Re: Appeal of the ISD permit B24-000161 (16-20 Medford Street) and of
Failure to act for Request for Enforcement 16-20 Medford Street (B24-000161)
Premises: 16-20 Medford Street
Permit(s): B24-000161

Notice of Administrative Appeal

Premises: 16-20 Medford Street, Somerville, Massachusetts 02143

j. Bay Window

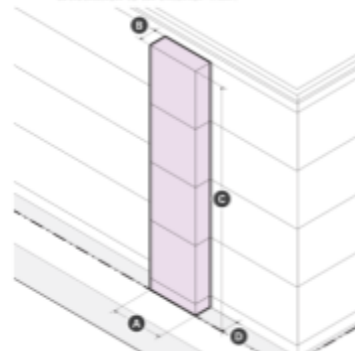
In particular, the Bay Windows are not allowed to encroach on the Curb Setback.

No Curb setback encroachment allowed

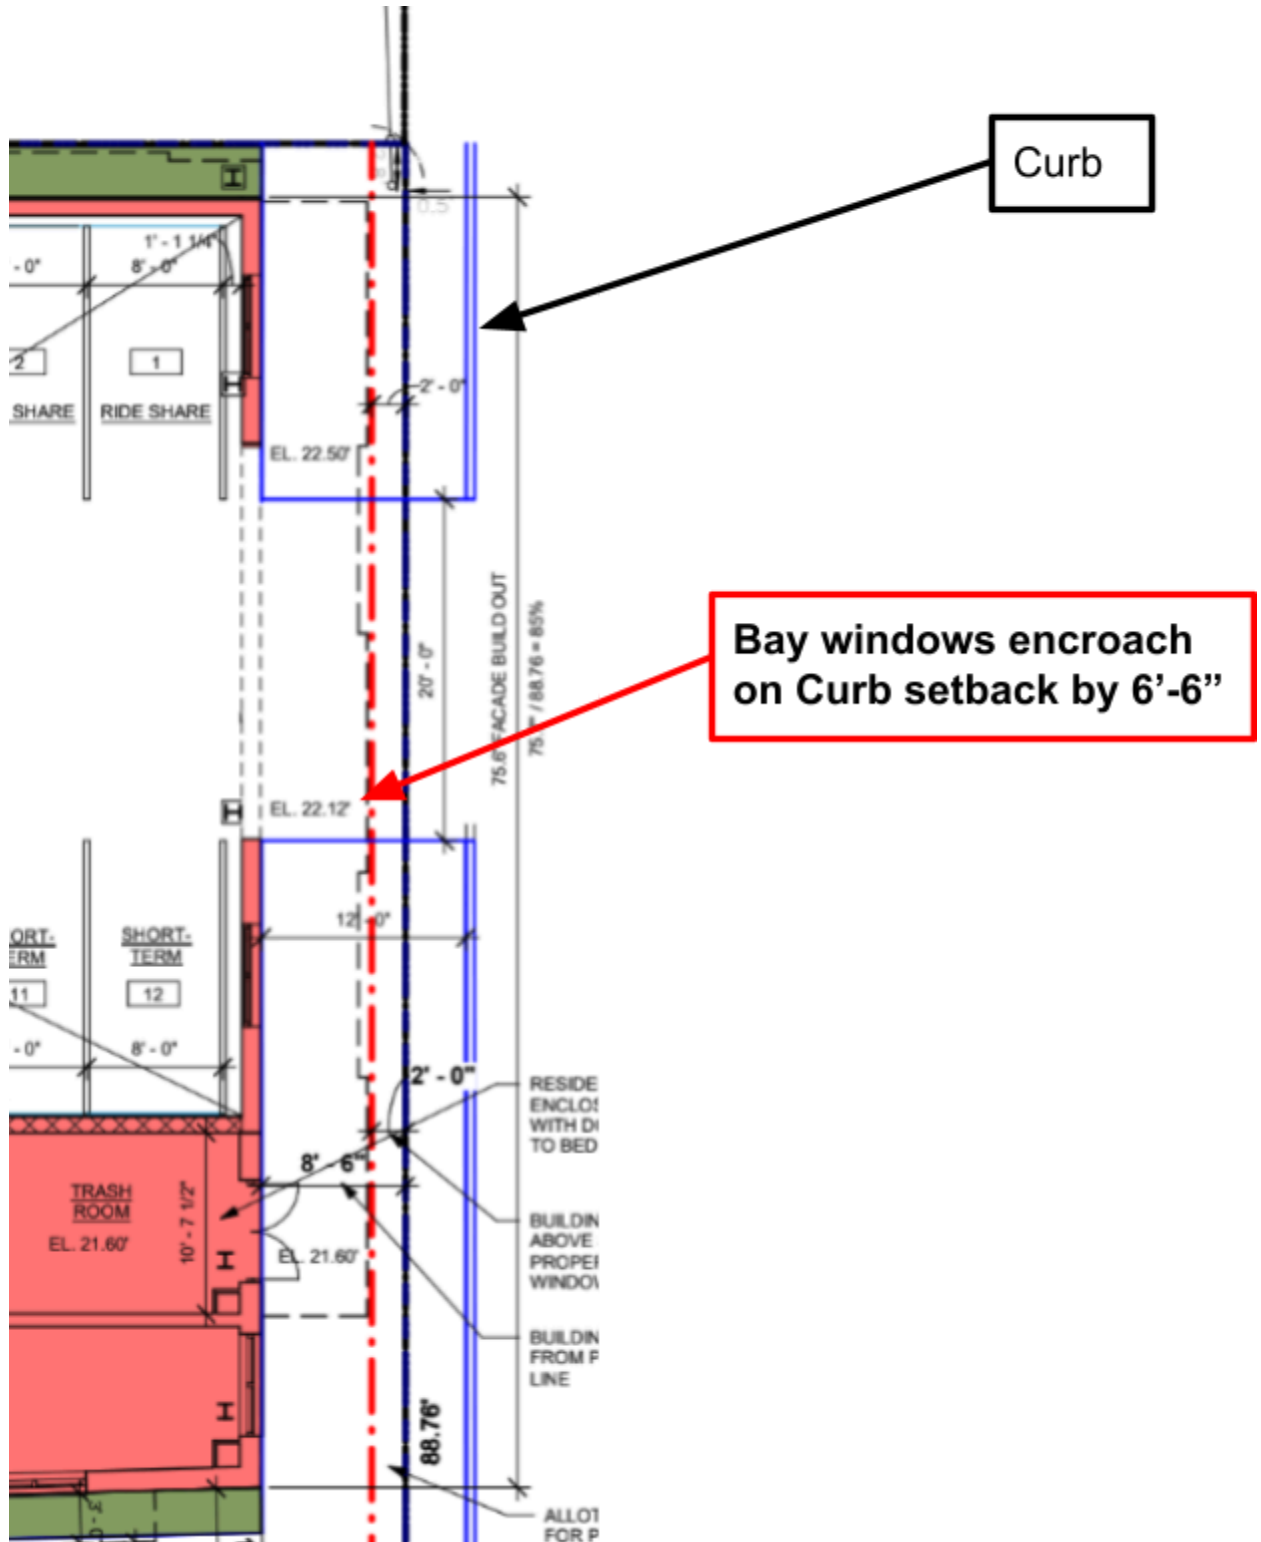
Please note that no building components (including Bay Windows) can encroach on the Curb Setback, per SZO. The corresponding setbacks for 16-20 Medford Street are depicted below:

Please note that there are a lot of building components (decks, bay windows), especially on the Warren Street and Bedford Street sides, encroaching onto Curb Setback according to permit plans. All these building components should be re-designed to not encroach on the Curb Setback.

2. Conflating curb and front setbacks would make the designation of curb setbacks in the SZO completely superfluous. Ordinance should be read to give each requirement meaning.
3. Notwithstanding (1) above, if such setback encroachments were allowed, on Bedford and Warren Street sides, the curb setback encroachments are greater than 3ft allowed for bay windows, which would violate SZO anyway. Here is the Bedford Street side, and the Bay Windows here encroach the Curb Setback by 6 ft 6". Similar issues are for Warren Street side:

The intent of the curb setback is to furnish a space for a sidewalk in the frontage of a building. Curb setbacks are necessarily treated as front setbacks for the purposes of reviewing building encroachment of building components. Per SZO §4.2.10.j.D, bay windows may encroach into a front setback by a maximum of 3 ft in an Mid-Rise 4 (MR4) district. Per SZO §4.2.10.k.B, balconies may encroach into a front setback by a maximum of 6 ft in an MR4 district.

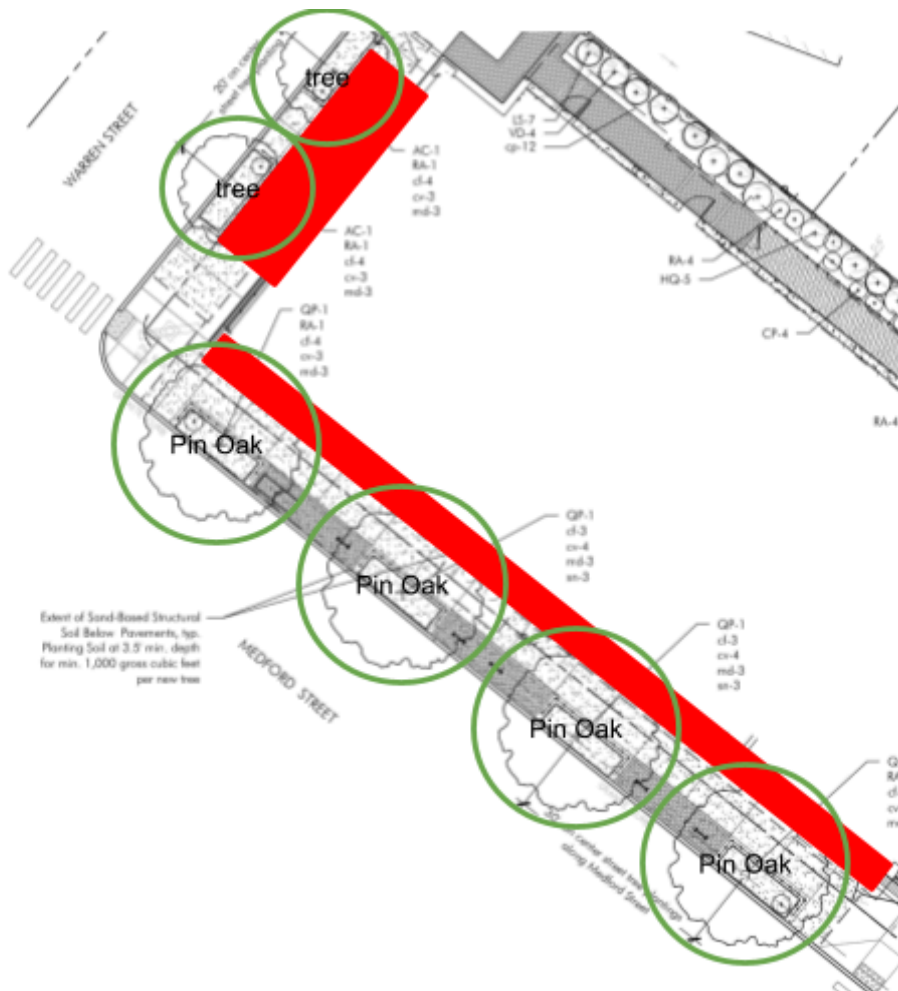
In fact, current Developers' landscape design depicted on page L2.1 already shows interference between tree canopies (green) and building components (red):

Note that the actual tree sizes above are severely under-estimated, and interferences actually are significantly more severe. The trees along Medford Street are specified as “Pin Oak”, which is classified as “large tree”, with normal heights 70-90 ft, and radius of 26-46ft spread ([https://en.wikipedia.org/wiki/Quercus palustris](https://en.wikipedia.org/wiki/Quercus_palustris)). These trees do not fit this space at all. But even smaller trees cannot be accommodated by the provided 6 feet clearance from the building if the curb setback would allow encroachments as ISD suggests (see tree size chart here: <https://arbordayblog.org/treeplanting/need-know-planting-right-tree-right-place/>). SZO reasonably mandates no encroachments for curb setbacks exactly for this reason.

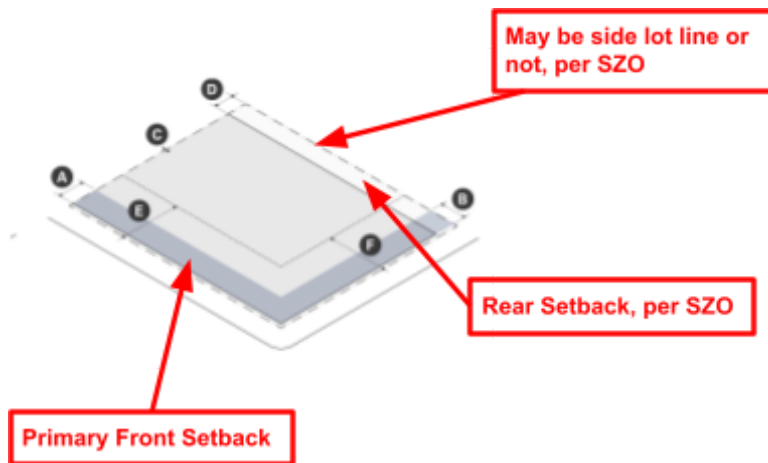
Regardless of the lot line designation, because it is located opposite of the Primary Front Lot Line (Medford St) of 16-20 Bedford Street, a REAR SETBACK is applicable to this lot line, by contextual drawing per SZO §4.2.8. b):

Here, the “Rear setback” (D) is depicted as the opposite of the “Primary front setback” (A). It is reasonable to assume that prescriptive drawing would mandate the rear setback to be located along the opposite side of the Primary Front Lot Line. Please note that the line with Rear Setback may or may not be a Rear Lot Line, which, per SZO, depends on the adjacent lot’s arrangement. The lot on the drawing may or may not have a rear lot line at all.

The lot lines of the Project abutting 7 Bedford St and 51 Warren St were determined to be side lot lines, not rear lot lines. Per SZO §2.1.1, a rear lot line is any lot line which is parallel to or within forty-five (45) degrees of being parallel to a front lot line, unless that lot line is a side lot line of an abutting lot. Both lot lines abutting 7 Bedford St and 51 Warren St are side lot lines of abutting lots. Rear setbacks would not be applicable to these lots, as rear setbacks are measured from rear lot lines.

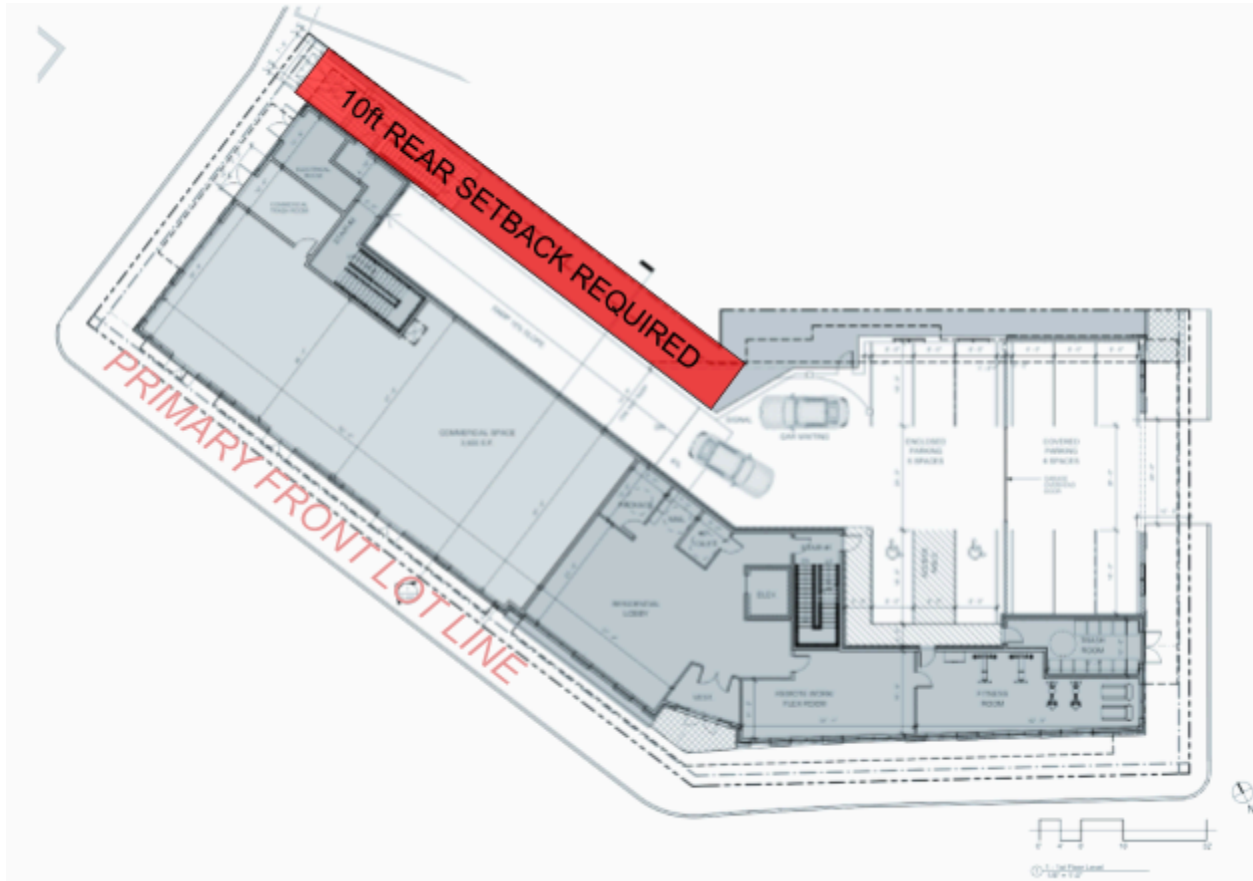
The required setback is depicted in RED on the figure above. As one can see, there are a lot of building components that encroach onto this setback. The Developers should reconfigure the building in order to not encroach onto this setback.

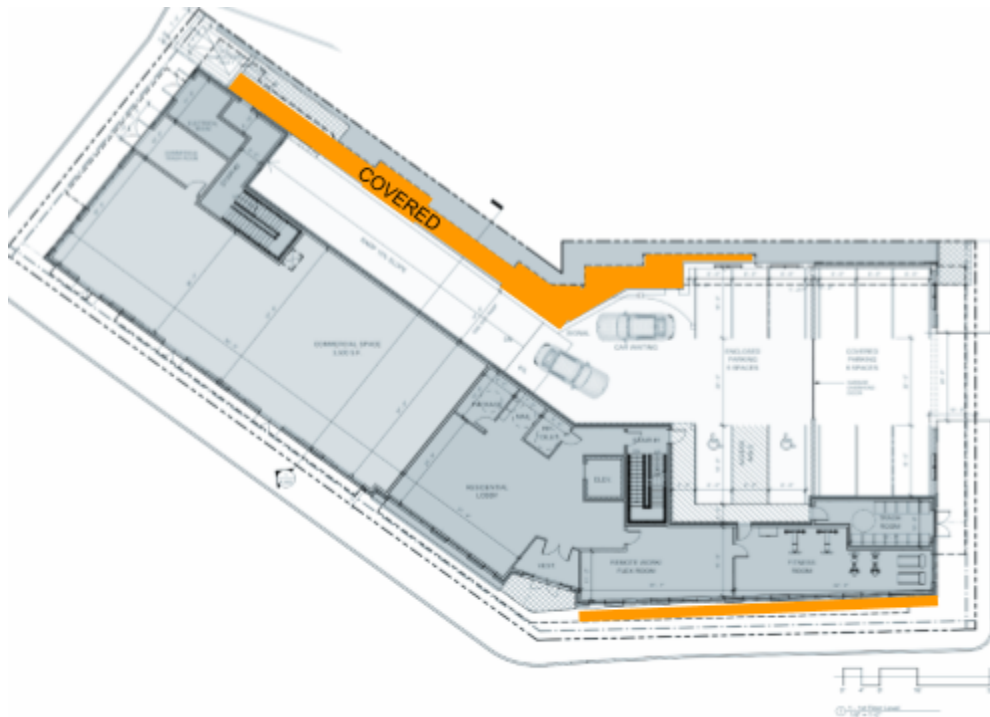
The Developer’s calculations claim lot coverage of the proposed development as 89.2%.

However, the calculation doesn’t count landscaped areas that are overhung by the building towards lot coverage. This is incorrect, because the structure above fully obstructs these areas from rainfall (as well as sunlight).

In addition, developers assume “permeable” pavers as having zero runoff coefficient and do not count them towards lot coverage. This is not appropriate. A zero runoff coefficient of

The approximate areas in question are marked in orange on the figure below:

Therefore, the actual lot coverage exceeds the maximum allowed by at least 1,000 sq. ft (95% instead of 90% max).
